The high-frequency pole of the reference CTLE in Annex 120E (comment #r03-12)

Yasuo Hidaka
Fujitsu Laboratories of America, Inc.

IEEE P802.3bs 200GbE and 400GbE Task Force
Electrical Ad Hoc, August 28, 2017

Figure 120E-9—Reference continuous time linear equalizer (CTLE) characteristic

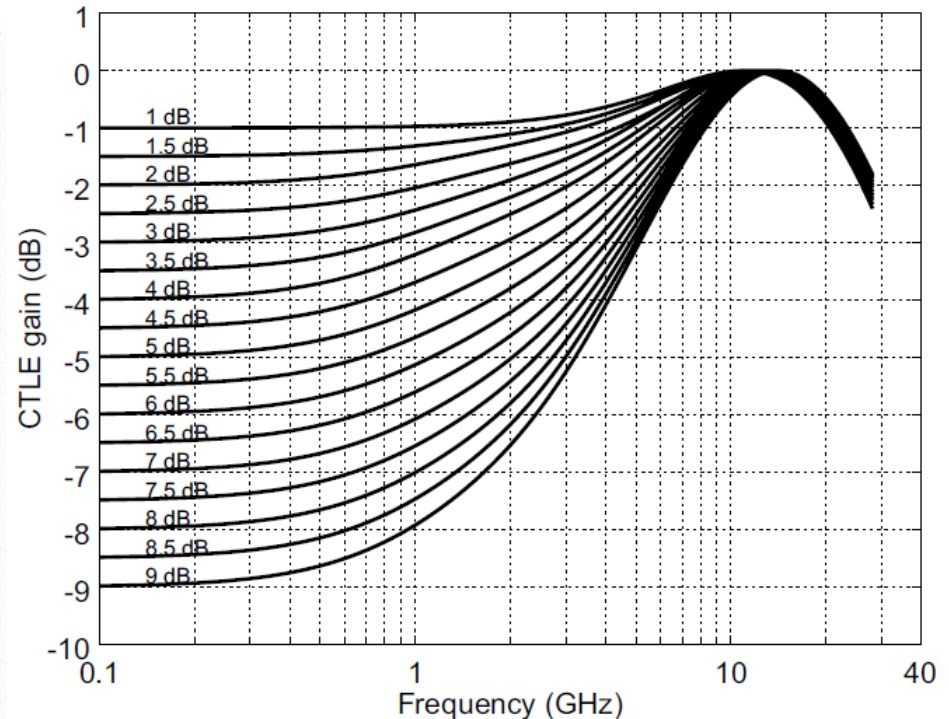
- A problem to realize stressed input test signal for 120E (C2M) was reported recently
- The high-frequency pole of the reference CTLE of 120E (C2M) is much lower than that of 120D (C2C)
- Aligning the high-frequency pole of 120E to that of 120D may resolve the problem

- This may be a serious problem as a standard, because nobody can generate a test signal to test Rx device

- High pole (P_1) is 15.6GHz ($= 0.587f_b$) or 18.6GHz ($= 0.7f_b$)
- Medium pole (P_2) is 14.1GHz ($= 0.531f_b$)

- For 120E, either option 1 or option 3 is recommended
 - Namely, increase the bandwidth of reference CTLE

Figure 120E-9 plotted up to $2f_b$

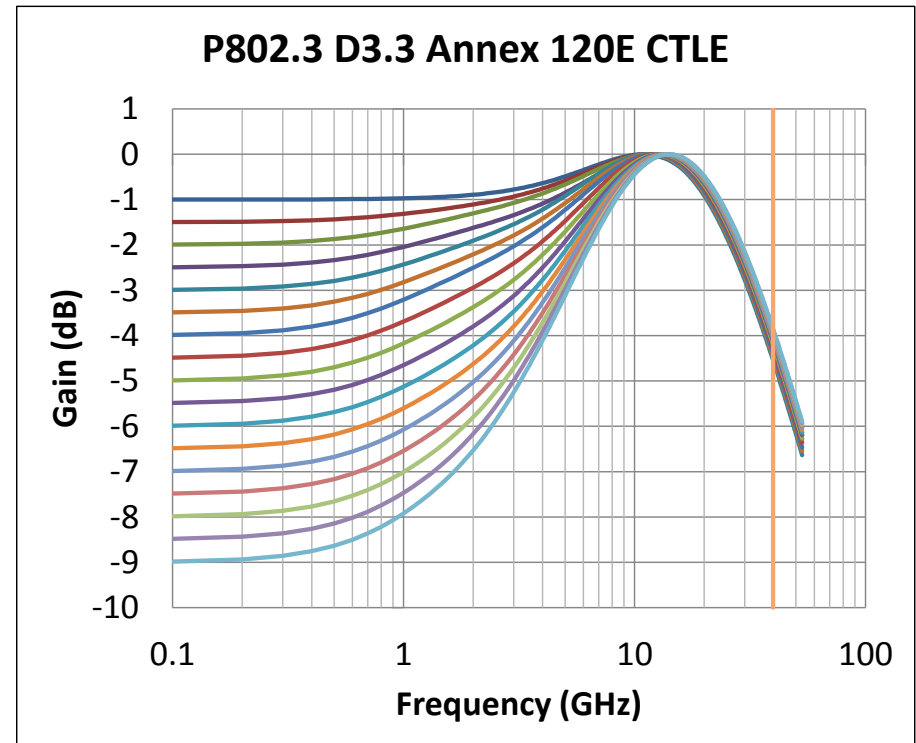
■ Gain at $1.5 \times f_b = 39.8GHz$ is $-4.3dB \sim -3.9dB$

Option 1

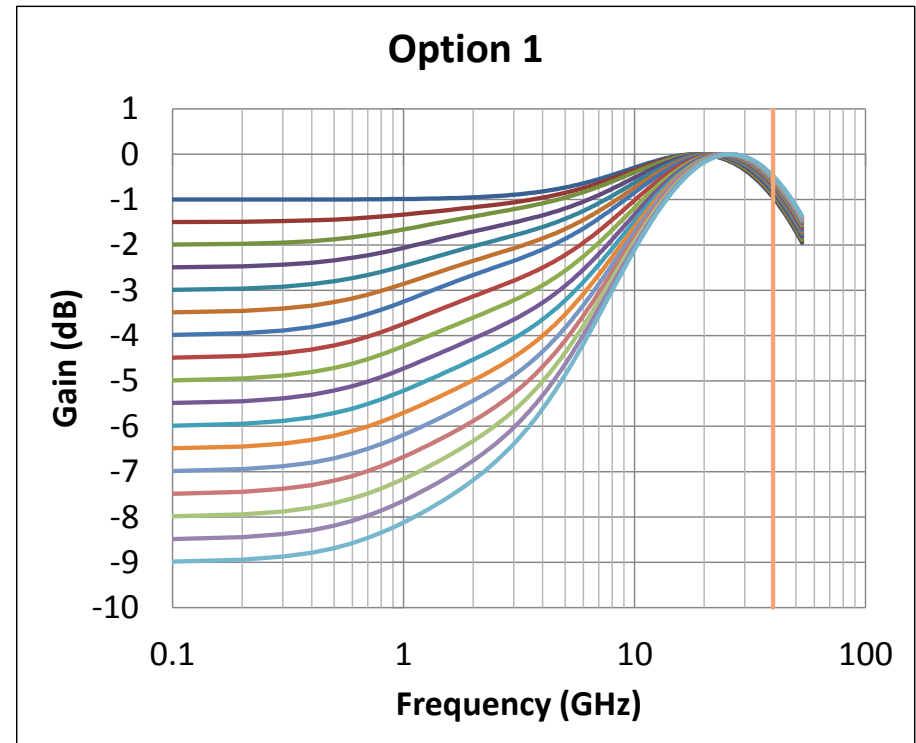
- Increase $P_1/2\pi$ to $2 * f_b$ (align to f_{p2} of Annex 120D)
- Gain at $1.5 \times f_b = 39.8GHz$ is $-1.0dB \sim -0.5dB$

- Either option 1 or 3 is recommended
 - Both of option 1 and 3 will improve the eye width
 - No significant difference between option 1 and 3
 - Align the high-frequency pole P_1 of 120E to f_{p2} of 120D

Option 2

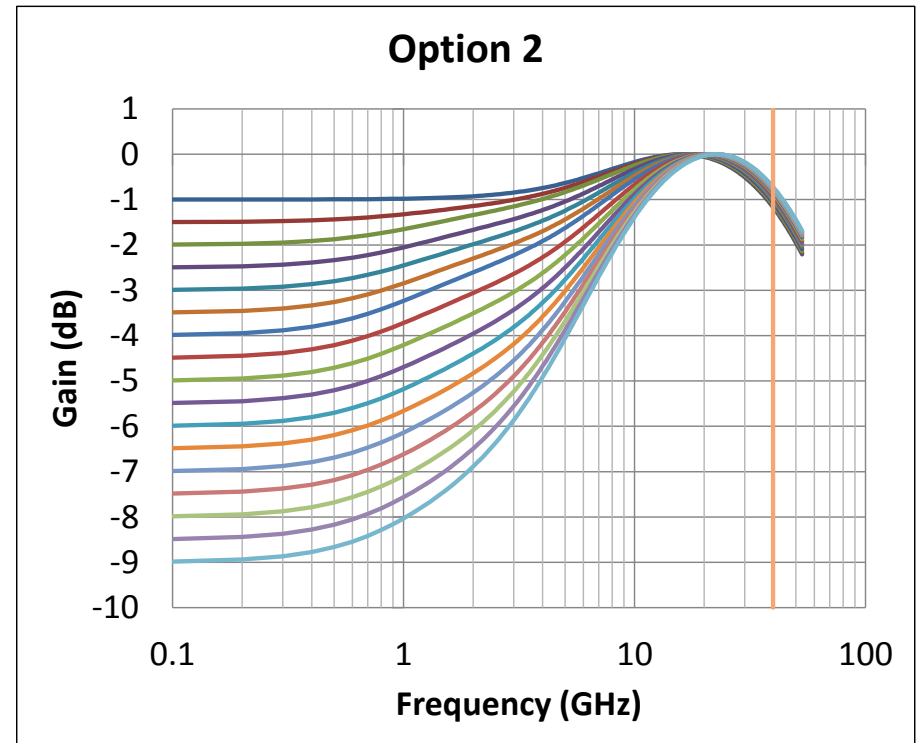
- Increase $P_1/2\pi$ to $2 * fb$ (align to f_{p2} of Annex 120D)
- Reduce $P_2/2\pi$ to $0.4 * fb$ (align to f_{p1} of Annex 120D)
- Gain at $1.5 \times fb = 39.8GHz$ is $-1.2dB \sim -0.7dB$

- Neither option 2 nor 4 is recommended
 - It will degrade the eye width, in particular with more impairments
 - Do not align the medium-frequency pole P_2 of 120E to f_{p1} of 120D

Option 3

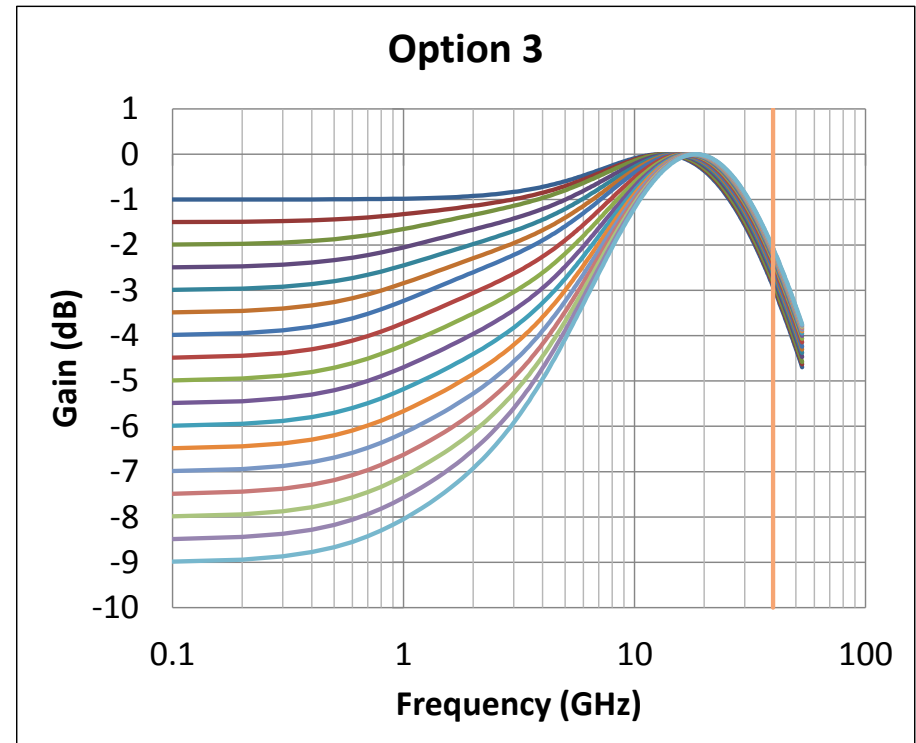
- Increase $P_1/2\pi$ to $1 * f_b$ (align to f_{p2} of CEI-56G-MR-PAM4)
- Gain at $1.5 \times f_b = 39.8GHz$ is $-2.9dB \sim -2.1dB$

Option 4

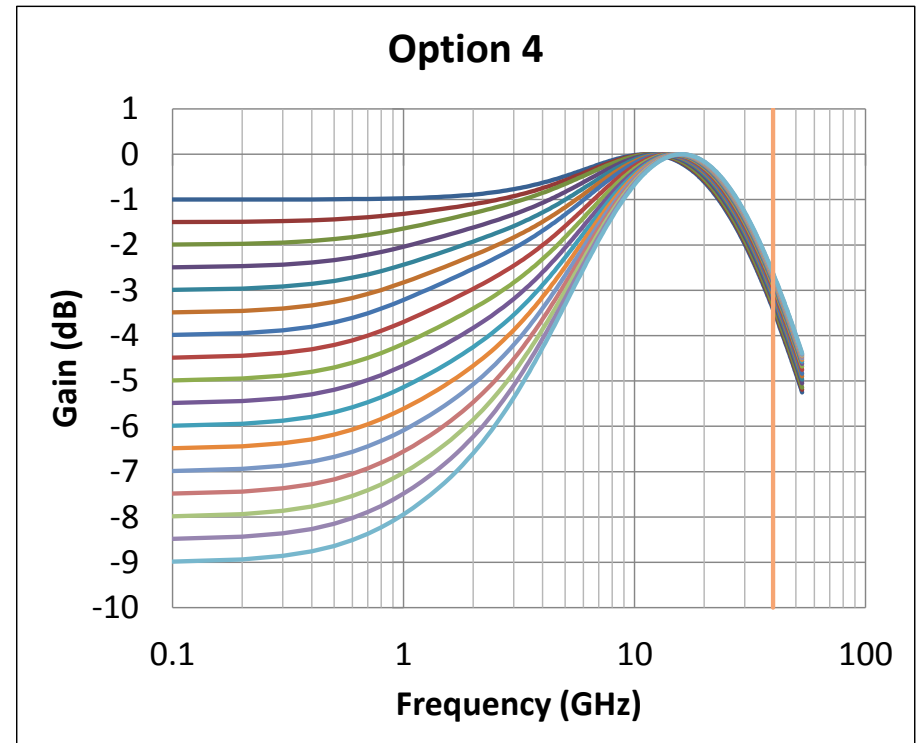
- Increase $P_1/2\pi$ to $1 * fb$ (align to f_{p2} of CEI-56G-MR-PAM4)
- Reduce $P_2/2\pi$ to $0.4 * fb$ (align to f_{p1} of CEI-56G-MR-PAM4)
- Gain at $1.5 \times fb = 39.8GHz$ is $-3.3dB \sim -2.5dB$
